Approved as Submitted
Matthew Juley
City of Mill Creek Supervising Engineer
07/19/2020

COVER SHEET

CREEKSID WEST
Snohomish County, Washington
PORTION OF SECTION 33, TOWNSHIP 28 NORTH, RANGE 5 EAST, W.M.
VILLAGE LIFE

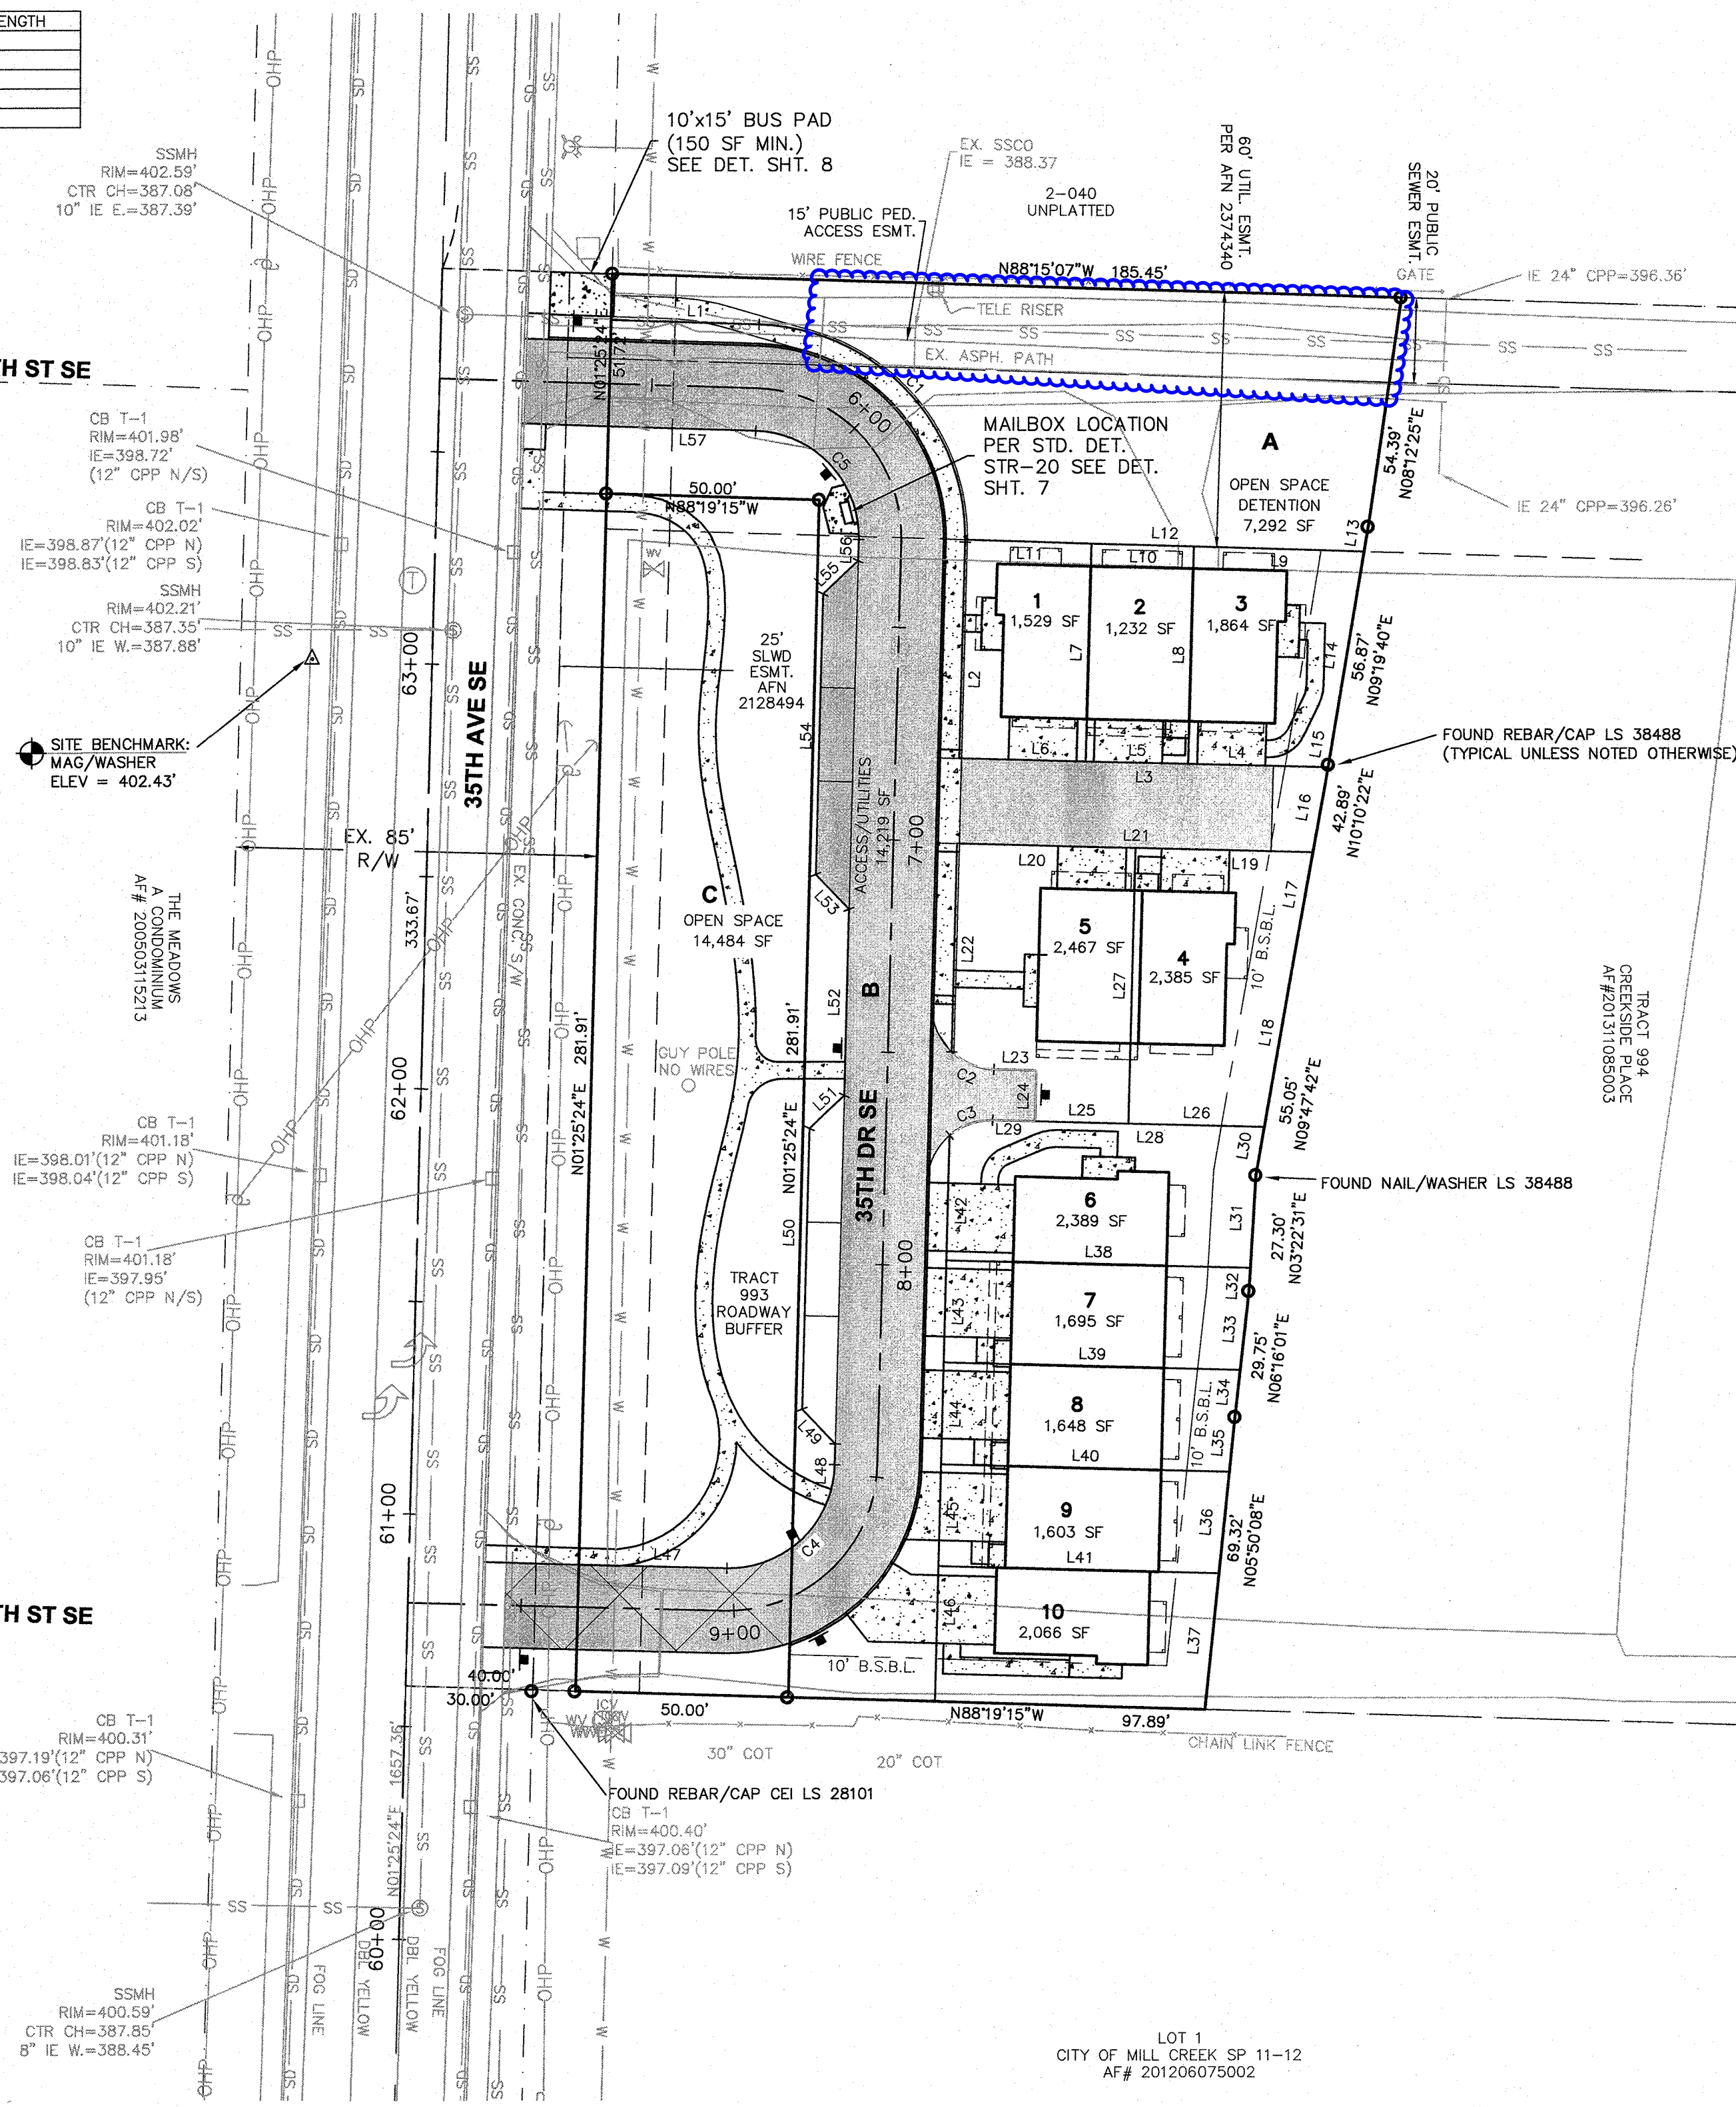
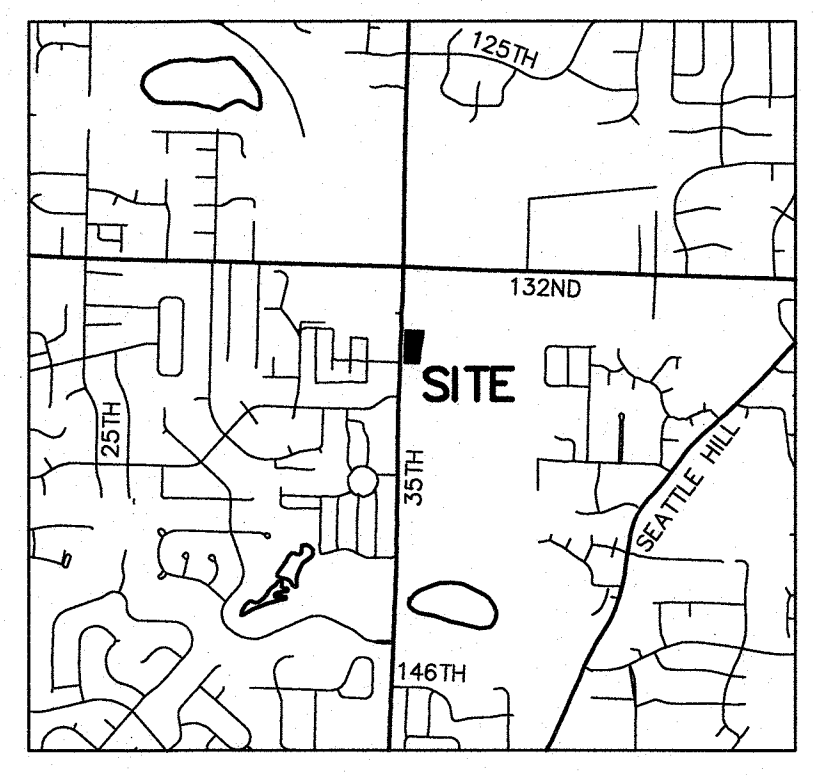
Field Note Revision 4-26-21 to shift northern pedestrian path to the south to align with existing walkway to the east - Approved by Christi Schmidt. To be shown on As-Builts.
